## REQUEST FOR INFORMATION

RFI NUMBER	<b>NL-RFI-033</b>					
ISSUE DATE (YY/MM/DD)	March 4, 2011					
PRIORITY	H	X	M		L	
REQ'D RESPONSE DATE	March 11, 2011

Hope Bay Mining Project

Subject:	Landfarm Material Variance	Project Zone/Area:	Doris North / Doris
Company:	Nuna Logistics Ltd. (Nuna)	Station/Location:	Landfarm
Attention:	Doug Fielding/Jerry Graham	Discipline:	Civil

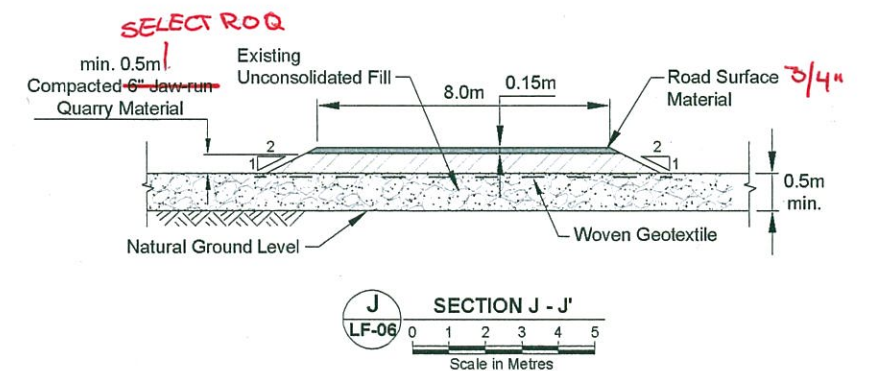
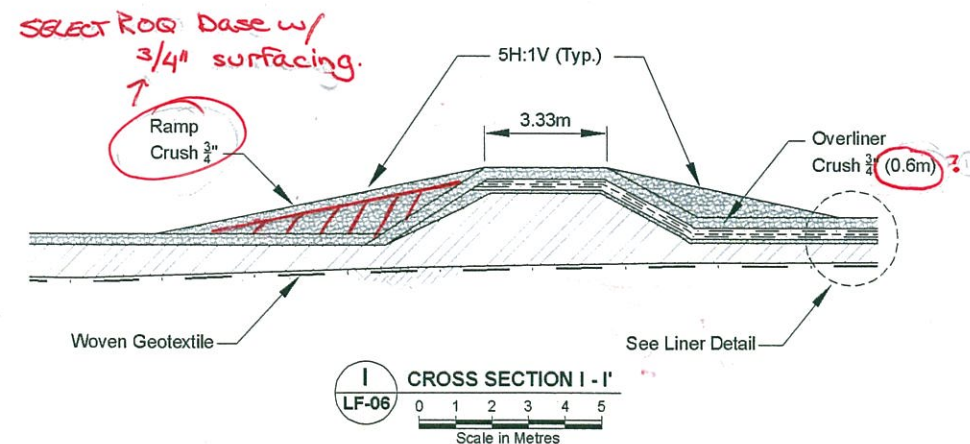
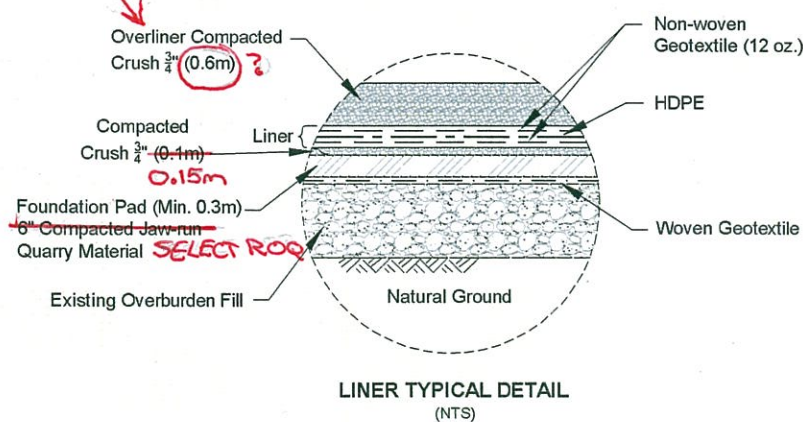
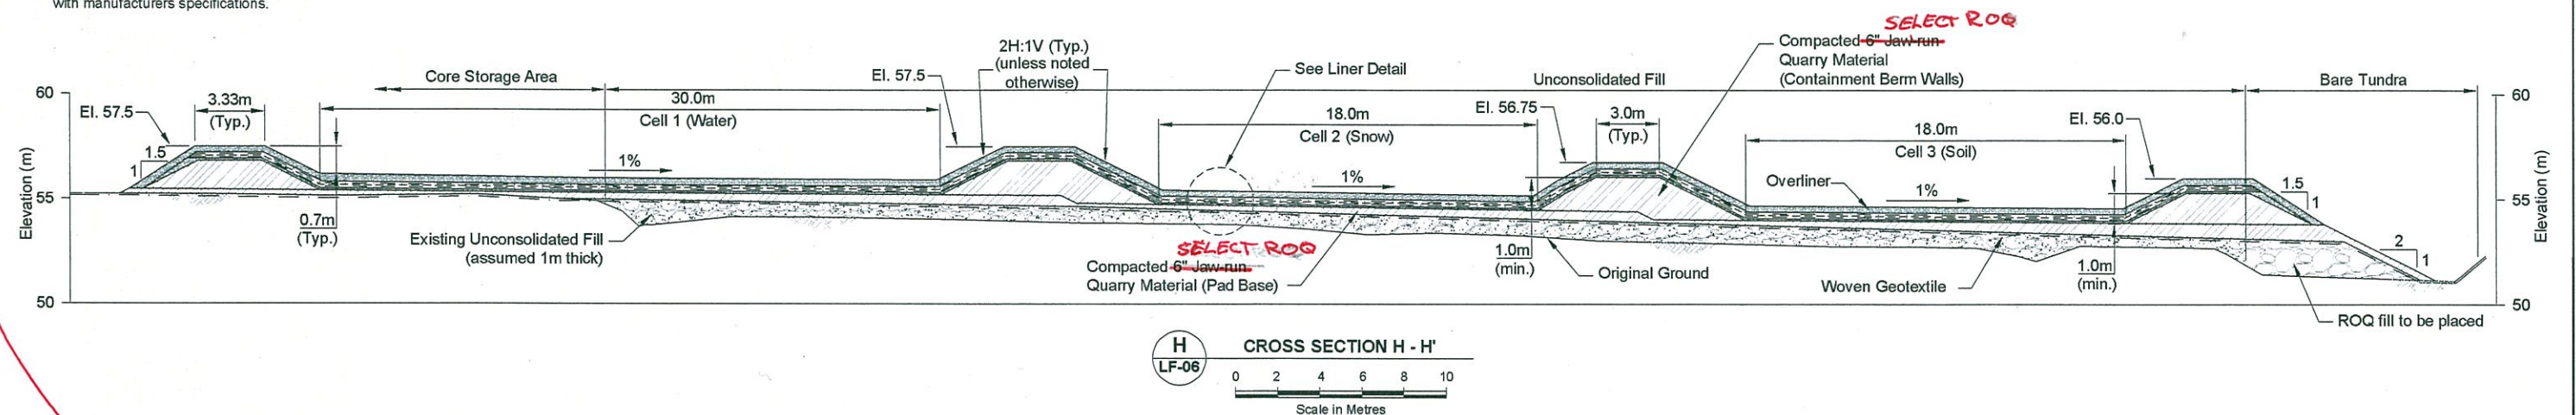
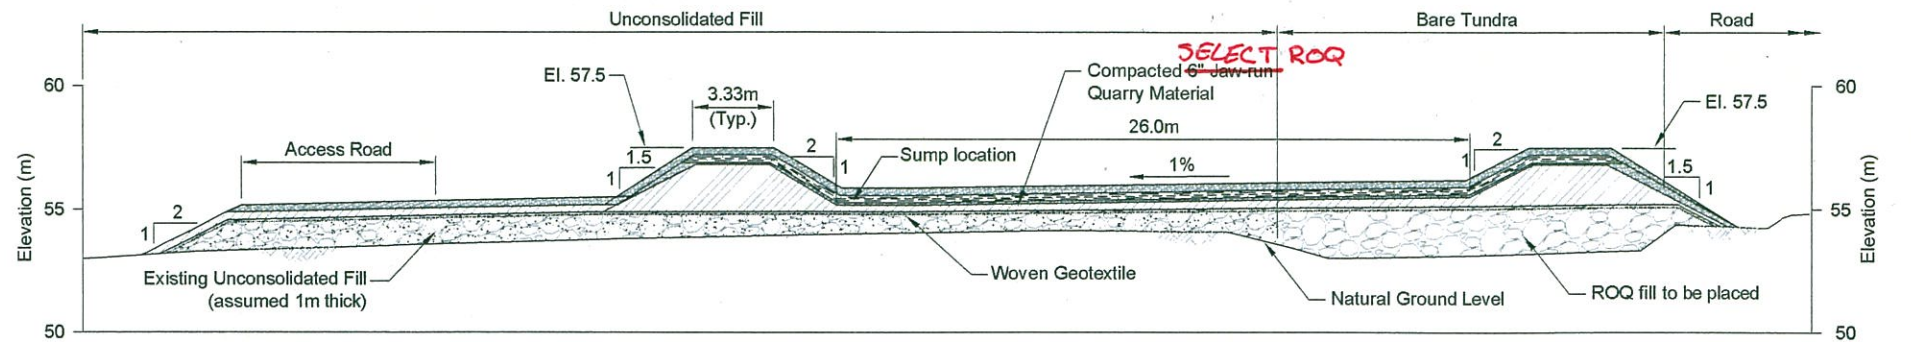
Upon reviewing the engineered Issued for Construction drawings for the Doris Landfarm, Nuna has identified the ability to reduce project costs by varying the construction materials specified. Attached to this RFI is SRK Dwg No. LF-07, marked up to reflect the suggested material substitutions. Specifically, Nuna is suggesting that all 6" crushed material be substituted for a 'Select ROQ' material. Using 'Select ROQ' will eliminate the requirement to produce anymore 6" jaw-run this year decreasing the construction costs. Also, Nuna suggests that the compacted ¾" underliner layer lift thickness be increased from 0.1m to 0.15m to correct any undulations on the underlying 'Select ROQ' foundation pad. All ¾" material for this project will be sourced from existing stockpiles onsite produced in the 2010 crushing program, and therefore thickening this underliner layer will not increase construction costs.

Nuna requests that JDS/SRK review this request, along with the marked-up drawing attached, and provide acceptance to proceed with this substitution. Nuna requests that this information be provided by no later than March 11<sup>th</sup> so that manpower can be properly schedule should we be required to crush 6" jawrun.

Description	Material Specifications	Quantity
Foundation Pad: Base (min. 0.3 m)	<del>6" Jaw-run</del> quarry material <b>SELECT ROQ</b>	7,146 m <sup>3</sup>
Woven Geotextile	LP315 or equivalent 6 oz woven geotextile	8,153 m <sup>2</sup>
Foundation Pad: Berms	<del>6" Jaw-run</del> quarry material <b>SELECT ROQ</b>	5,353 m <sup>3</sup>
Non-woven Geotextile	12-oz non-woven geotextile	8,768 m <sup>2</sup>
HDPE Geomembrane Liner	Solmax 460T or equivalent 60 mil textured HDPE	4,384 m <sup>2</sup>
Overliner (0.3m) ?	3/4" crushed rock	1,366 m <sup>3</sup> <b>TOO LOW?</b>
Access Ramps <b>Surfacing</b>	3/4" crushed rock	128 m <sup>3</sup>
Underliner (0.1m)	3/4" crushed rock	564 m <sup>3</sup>
Road Base (min 0.5m)	<del>6" Jaw-run</del> quarry material <b>SELECT ROQ</b>	734 m <sup>3</sup>
Road Surfacing (0.15m)	<del>4 1/4"</del> crushed rock <b>3/4"</b>	192 m <sup>3</sup>
Berm Surfacing (0.3m)	<del>4 1/4"</del> crushed rock <b>3/4"</b>	1,366 m <sup>3</sup>

Response:
The use of select ROQ instead of 6" jaw run has been previously discussed and is an acceptable alternative provided the existing lines and grades on the current IFC's are met. The existing drawing package has been reviewed and approved by the KIA. If the lines and grades are changed, a new IFC drawing package must be issued. This would require a Change Order submitted by SRK to Newmont and the new IFC's would then have to be re-reviewed by the KIA before construction activities could start.
Responsible Newmont Representative: <b>Lowell Wade</b>
Print: _____ Sign: _____ Date: <b>March 5, 2011</b>
